Addendum

Date: **06 May 2020**

Addendum No.	THREE
Project:	ARTIFICIAL INTELLIGENCE LAB UPFIT
	University of South Carolina
	Columbia, South Carolina
	WTS # 1919 OSE # H27-Z408
From:	Regina R. Floyd, AIA LEED AP BD+C
То:	Prospective Bidders / Plan Holders

A3.2

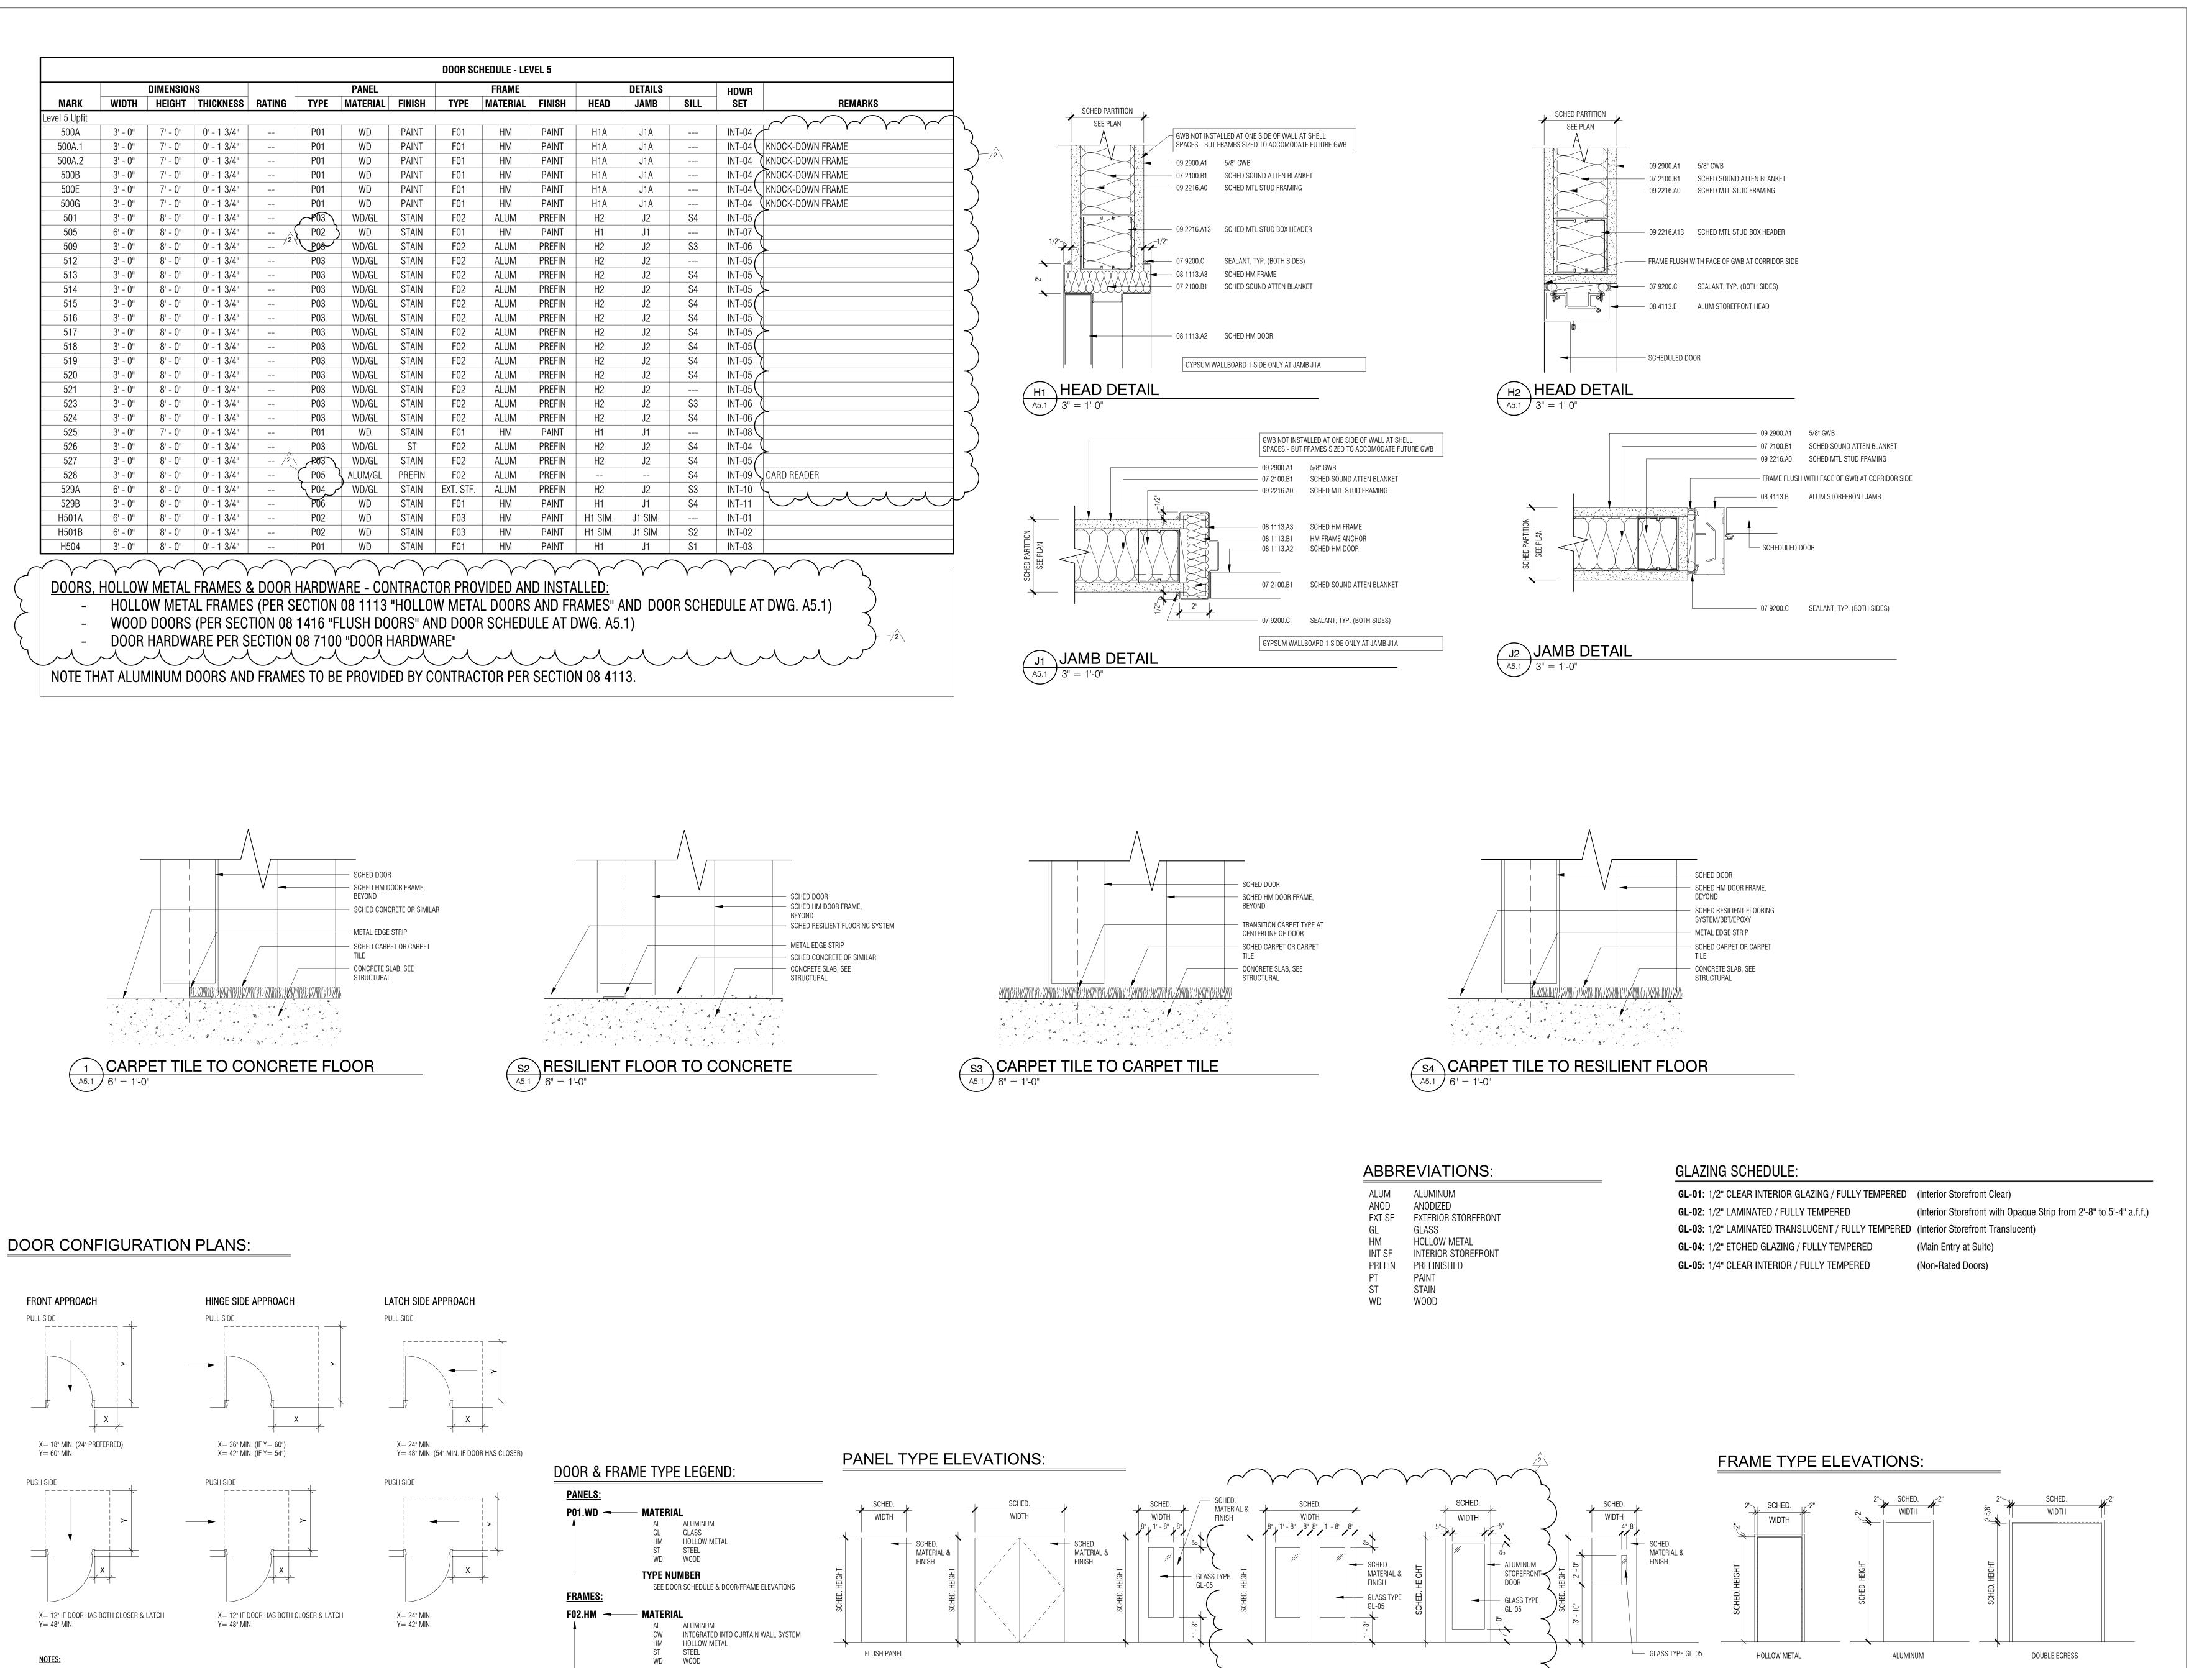
5. DRAWING A3.2 – INTERIOR ELEVATIONS:

- a. Elevation 3 / North Hallway North Elevation:
 - Removed incorrect door numbers that refer to former numbering at Building Shell.
- b. Elevation 5 / East Hallway East Elevation:
 - Removed incorrect door numbers that refer to former numbering at Building Shell.
 - Corrected door elevation at Door 501 into Quiet Room.

A5.1

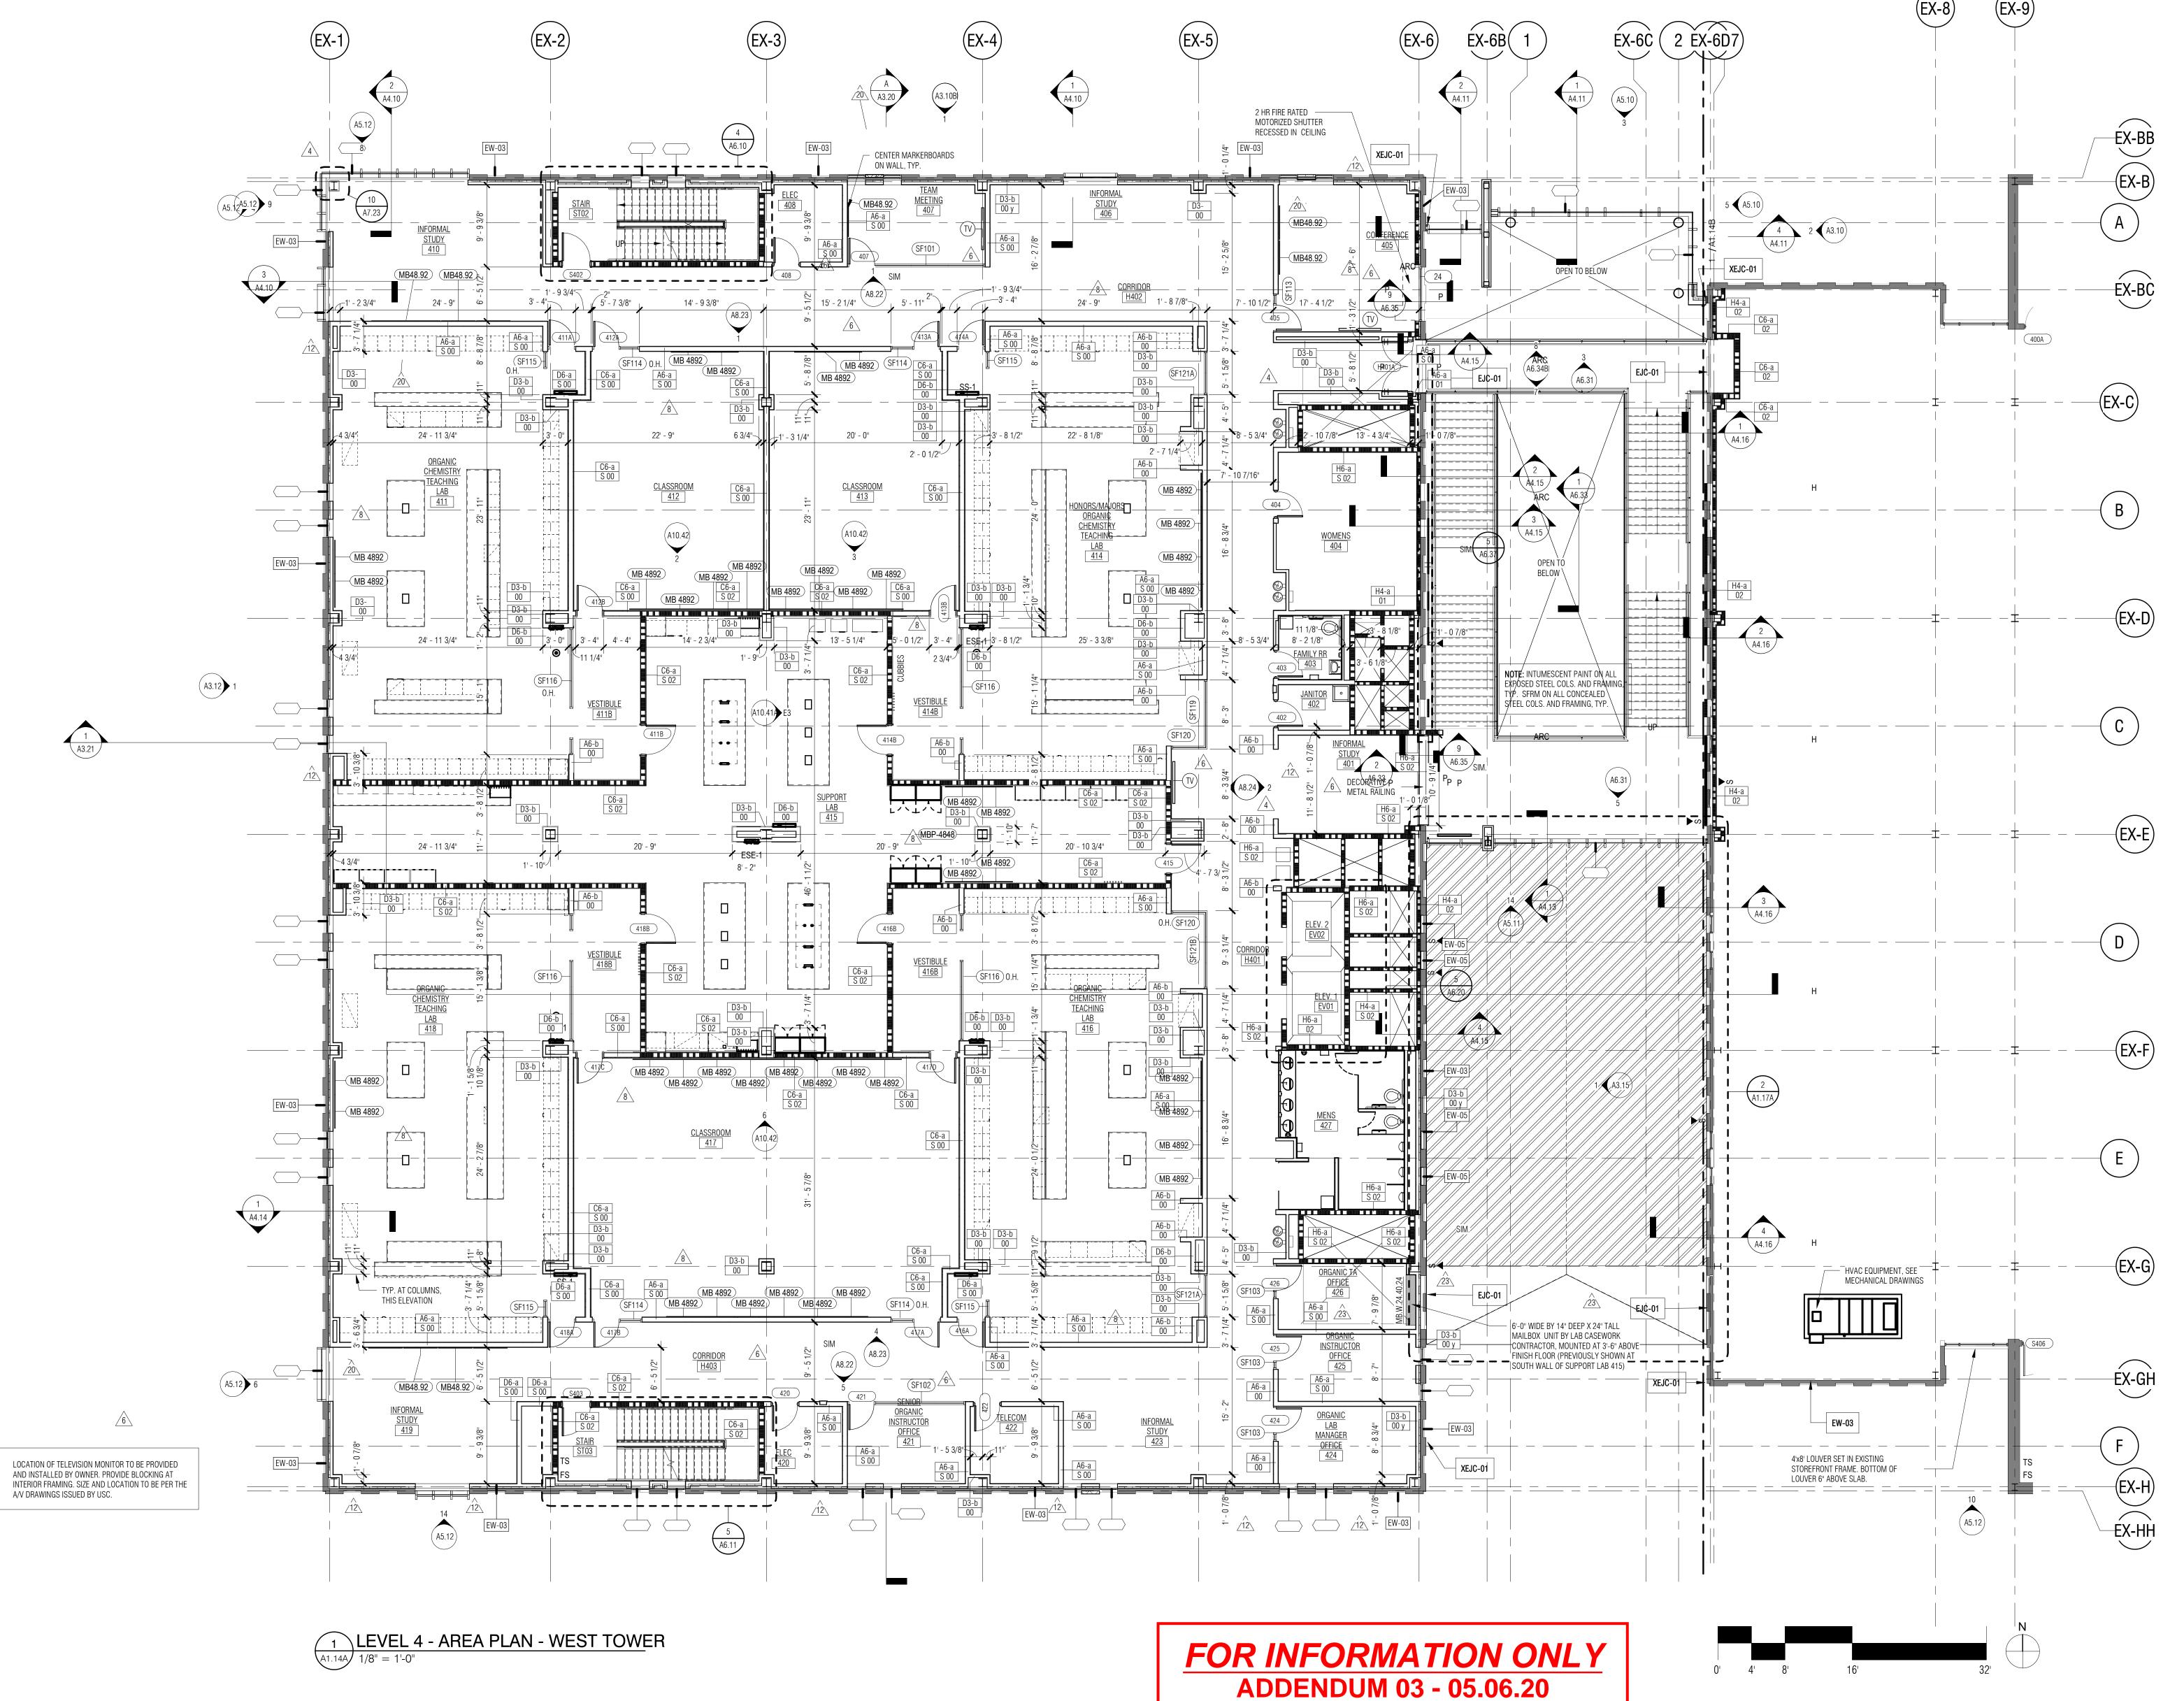
6. DRAWING A5.1 - DOOR SCHEDULE AND DETAILS:

- a. Replace with the attached Drawing A5.1, which has been revised as follows:
 - 1) Revised notes below Door Schedule to indicate that Doors, Frames and Hardware are to be both Furnished and Installed by Contractor.

- 2) Door Schedule:
 - Noted doors to receive knock-down frames.
 - Noted doors which will have access control.
 - Revised door 505 to be type P02.
 - Revised door 528 to be type P05.
 - Revised door 529A to be type P04.
- 3) Panel Type Elevations:
 - Added Type P04 (wood/glass double door similar to P03)
 - Revised Type P05 from double to single panel.

WEST TOWER -LEVEL 4 - AREA PLAN

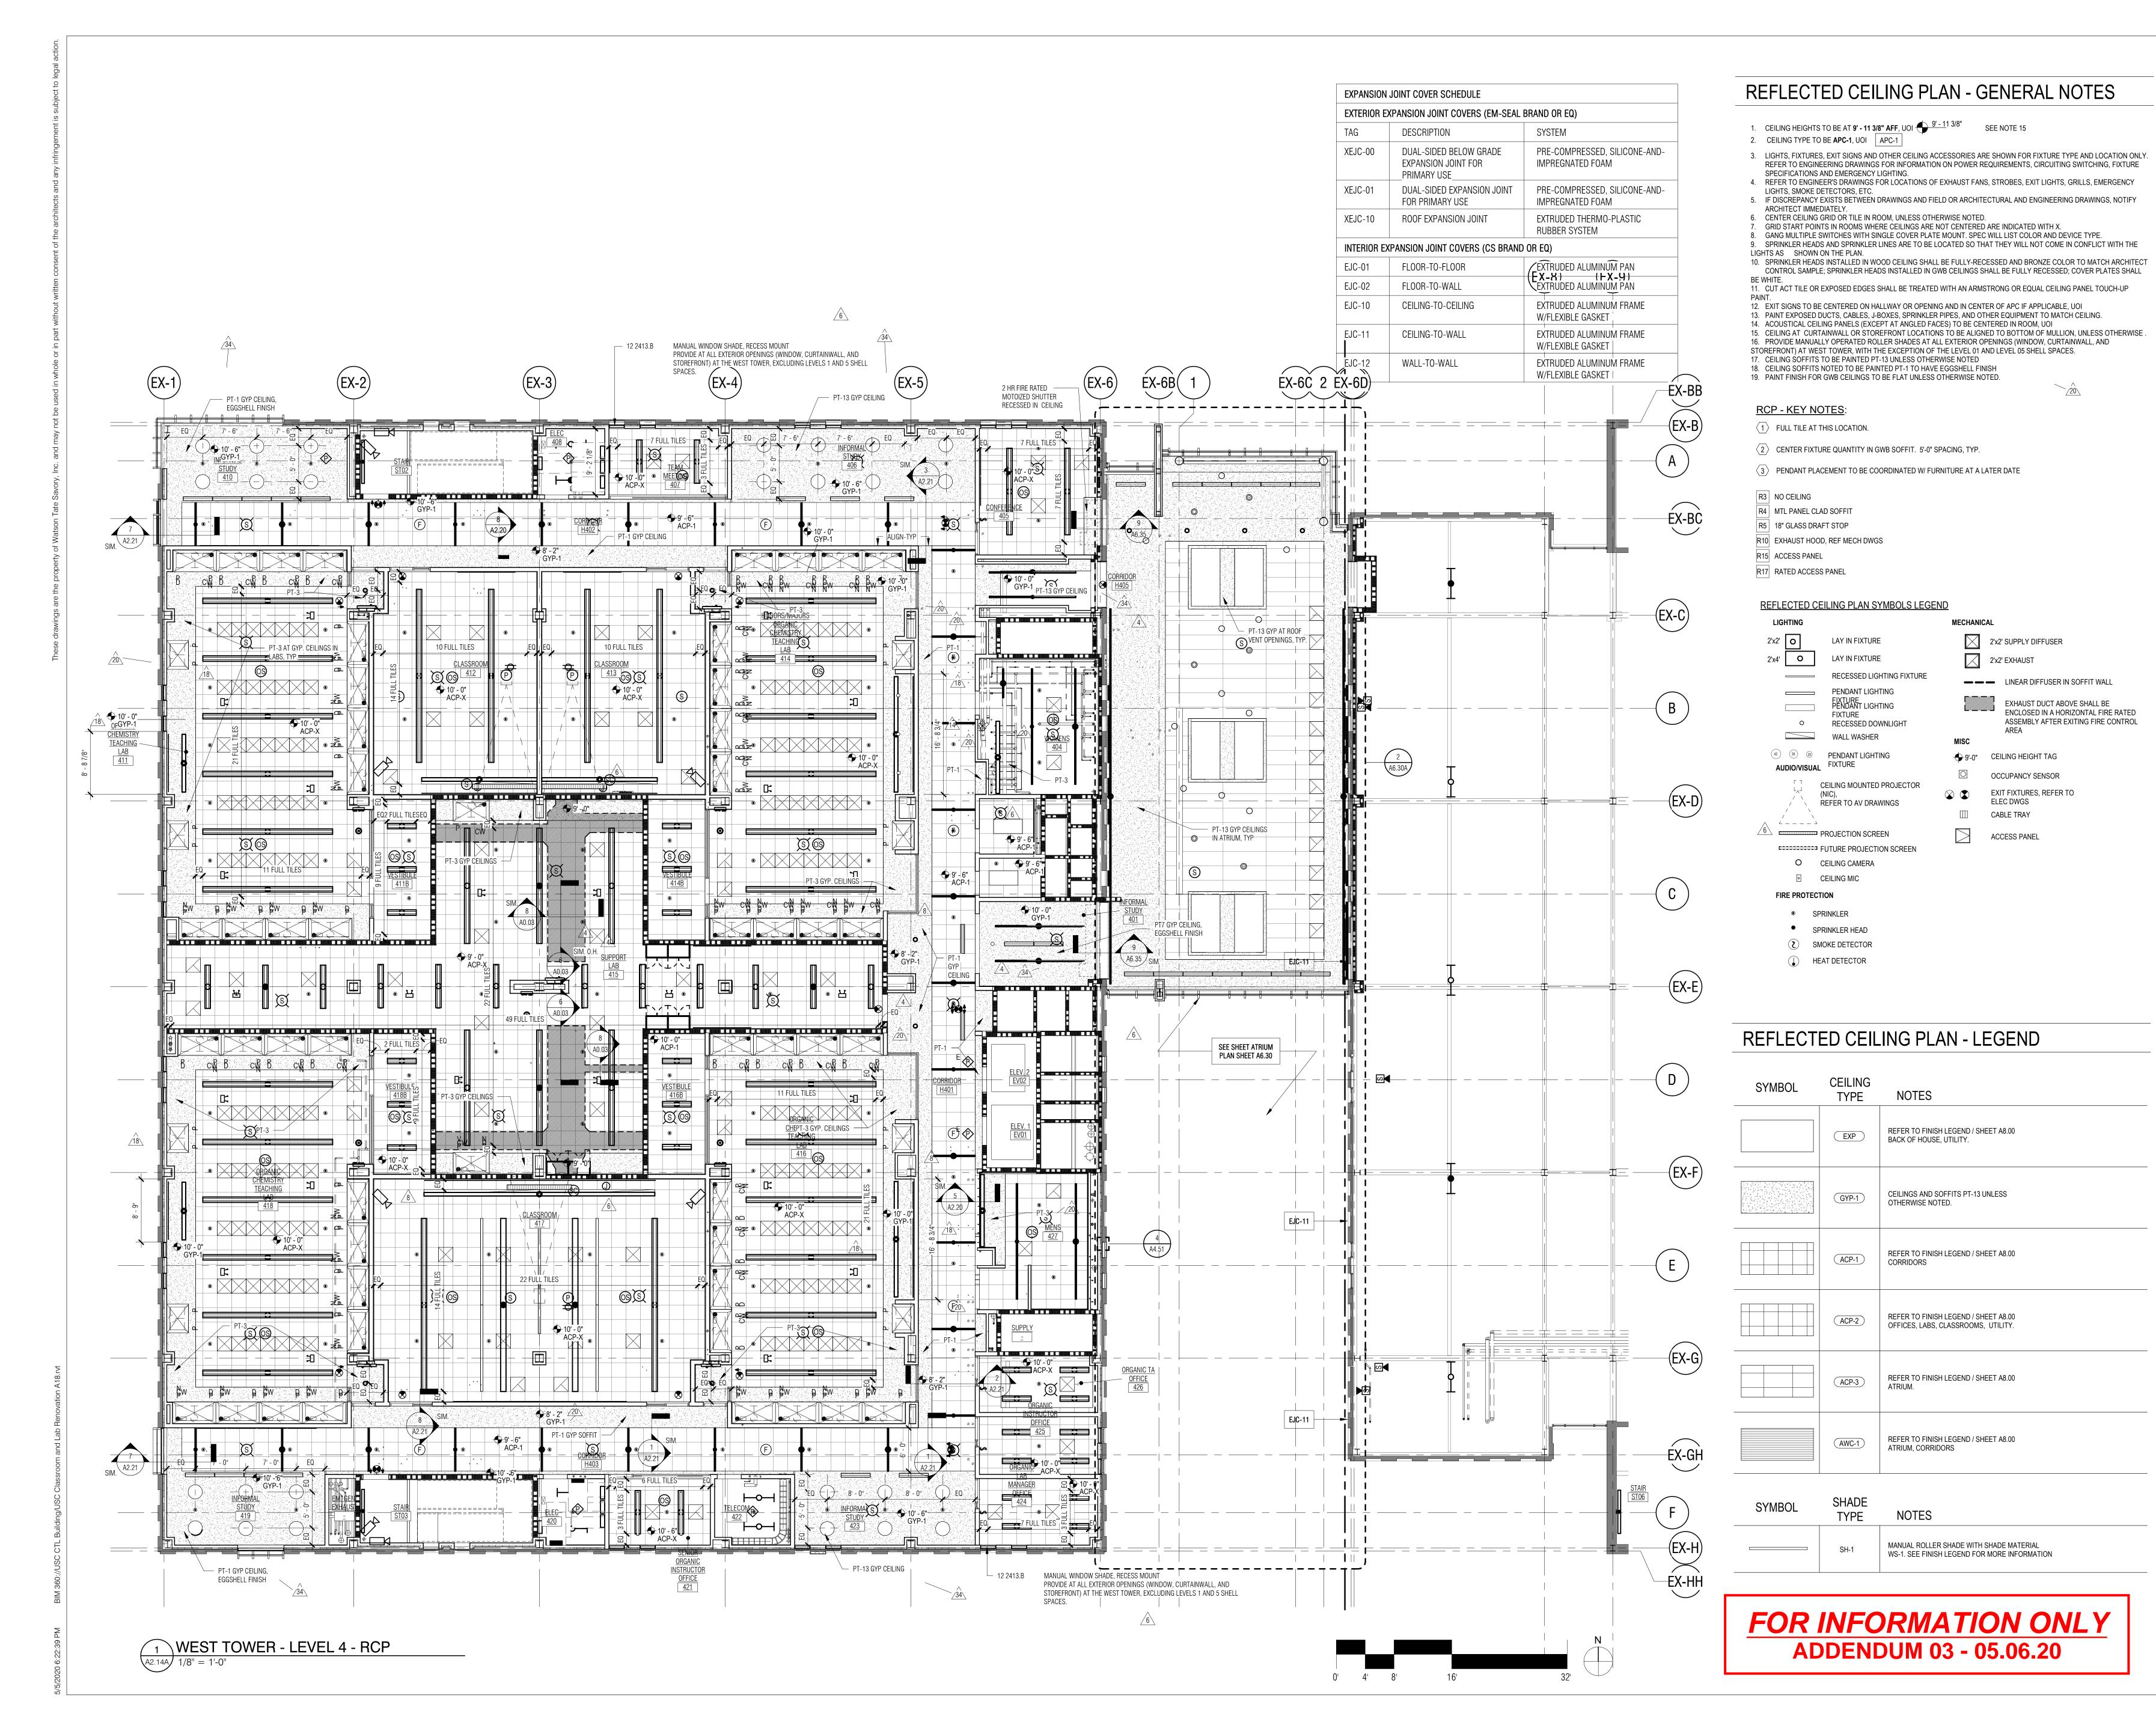
9. **Question:** P0-1 indicates for the tie in of the sanitary piping to be done on the 4th floor. What is the room below this tie in location?

Answer: A Conference Room is located at Level 4 below this area. Existing floor and reflected ceiling plans (Drawings A1.14A and A2.14A) from the Building Construction are included in this addendum for information.
